## ADDENDUM NO. 04

MOUNTAIN TRANSIT MAINTENANCE FACILITY

**FOR THE**  
MOUNTAIN AREA REGIONAL TRANSIT AUTHORITY (MARTA)

RCA Project No. 5-08-01

SEPTEMBER 2022  
 SHEET 3 OF 12  
 DRAWING NO. --

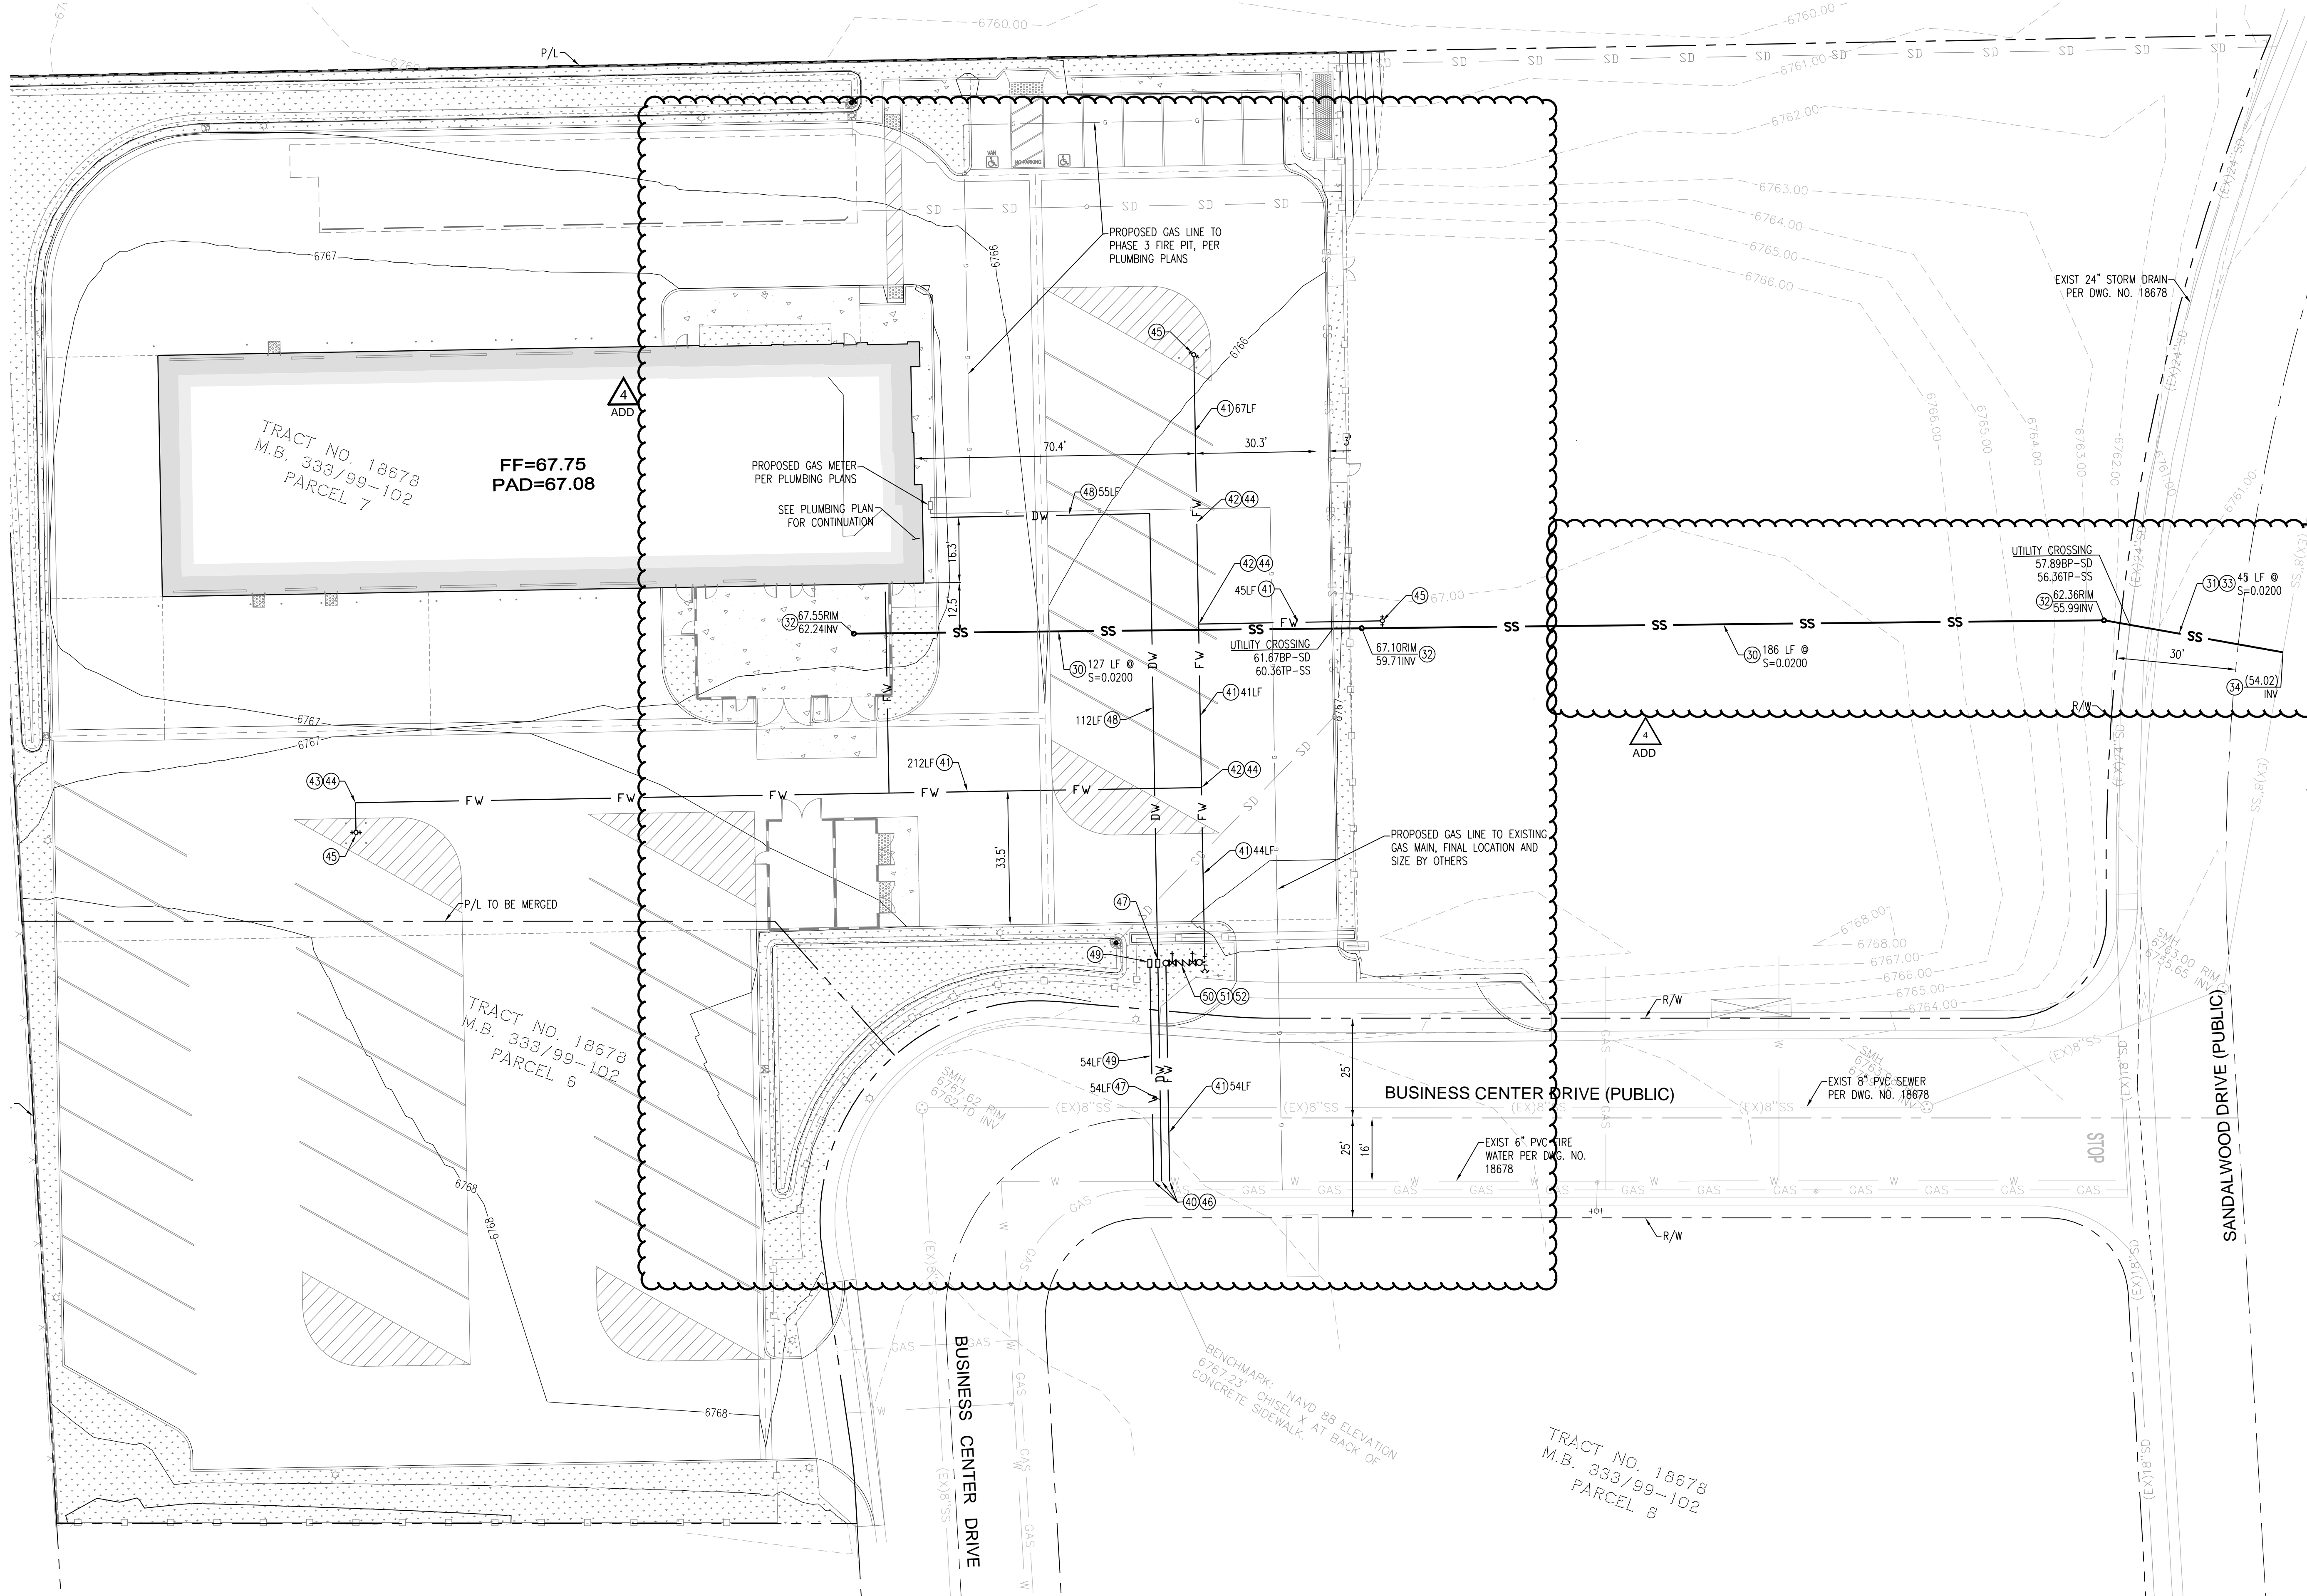
4.16.1 Replace Sheet 3 and revise per clouded areas listed below:  
a) Added retaining wall grades to plans.  
b) Revised ‘Construction Items’.
- Item No. 4.17 Reference Sheet 5 – Utility Plan

SHEET 5 OF 12

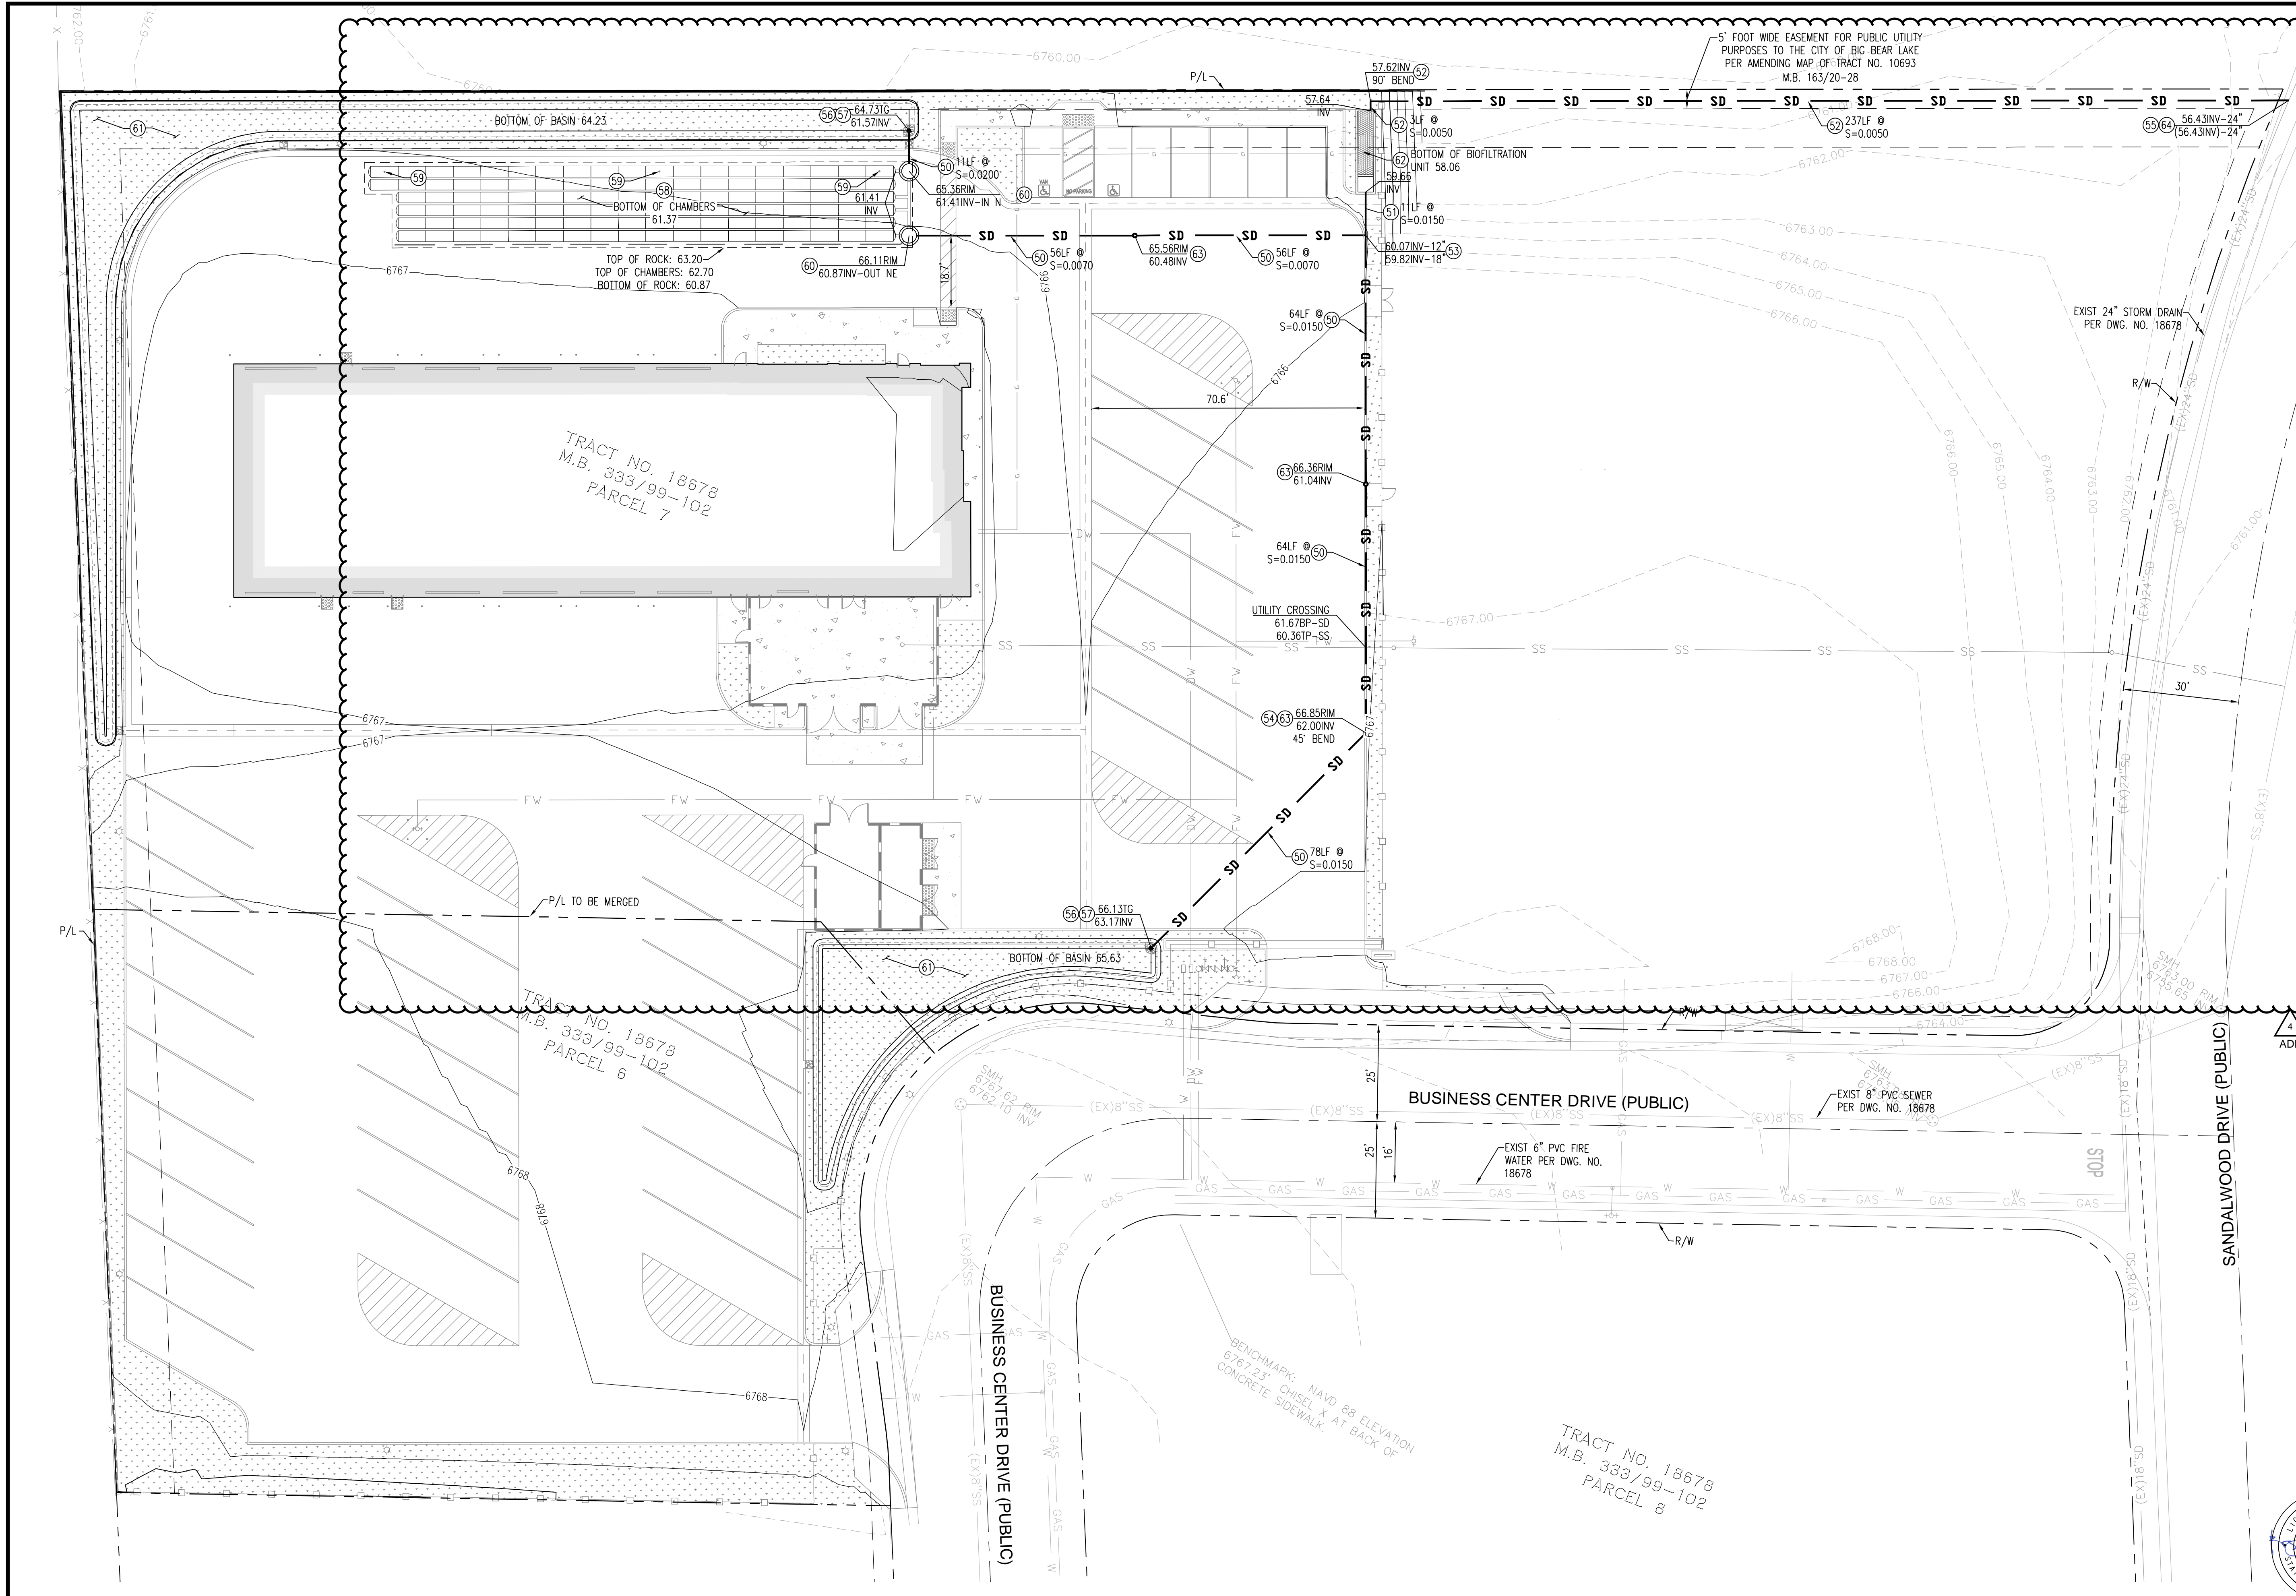
4.17.1 Replace Sheet 5 and revise per clouded areas.  
a) Adding 1” landscape water meter and backflow device.  
b) Adding 2” domestic water meter and backflow device.

c) Addition of an 8” DDCA backflow device with FDC.  
d) Separate domestic feed to the building to the proposed domestic meter.  
e) Addition of fire hydrant (to be utilized by Increment #3).

f) Water line locations revised.  
g) Sewer line location and inverts revised and updated.  
h) Revised “Sewer Improvements items”.  
i) Revised Water Improvements items”.

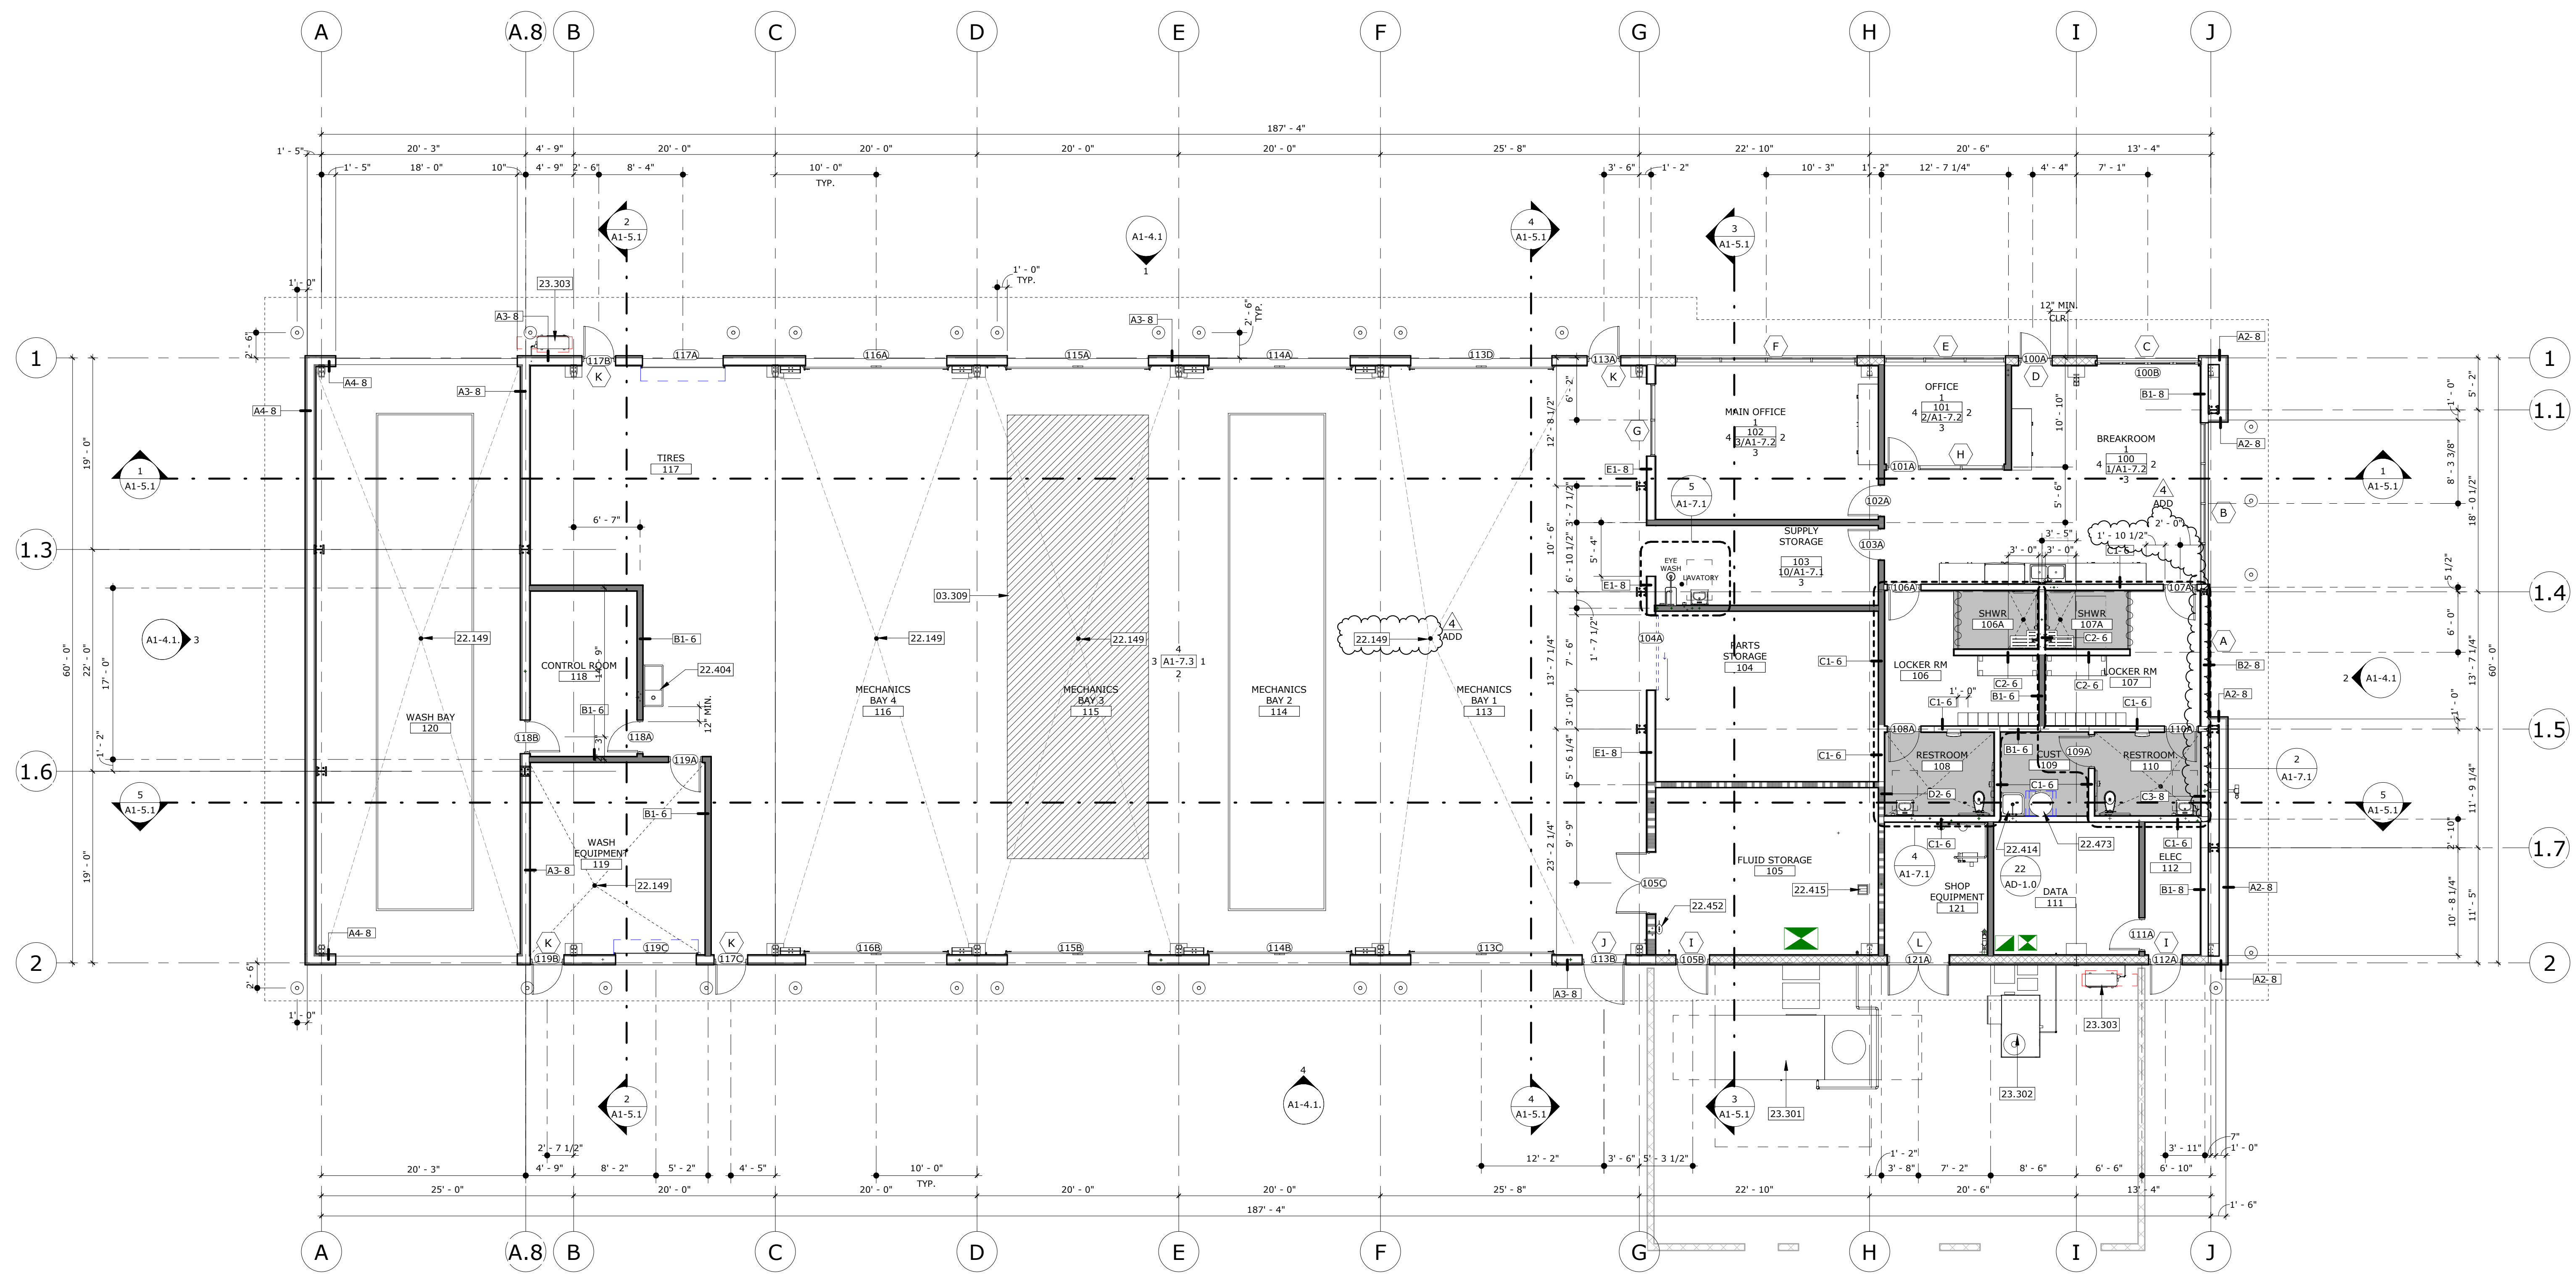
- Item No. 4.20 Reference Sheet A1-1.2 – Floor Plan
- 4.20.1 Replace Sheet A1-1.2 and revise per clouded areas listed below:
- a) Revised Floor Plan 1/A1-1.2 per clouded area.
    - a. Relocated floor drain in Mechanics Bay #113.
    - b. Revised Locker RM. #107 wall type and dimensions.
